# Joint Services Wiring Action Group

Primary Support Clamp

Deformation

Date: 01 JUL 24

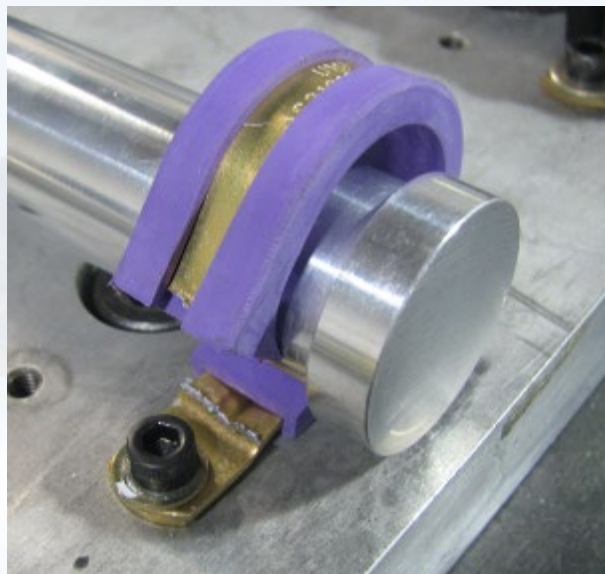
When a clamp manufacturer was asked if it was permissible to bend or flatten a clamp; the response was, “Our engineers do not recommend flattening or bending the clamp once it is installed since stress concentration can be introduced onto the metal, especially near the fastening area.”

Based on NAVAIR vibration testing in 2013 and the clamp manufacturers response to bending/ flattening, it is recommended that a caution statement prohibiting the bending/ flattening of clamps be added to the NAVAIR 01-1A-505-1 / TO 1-1A-14 / TM 1-1500-323-24-1

- Caution statement has been approved and will be included into the next change/ revision of the NAVAIR 01-1A-505-1 / TO 1-1A-14 / TM 1-1500-323-24-1, WP 010 00 para 47.

Bending / flattening of clamps are prohibited as it may lead to premature failure.
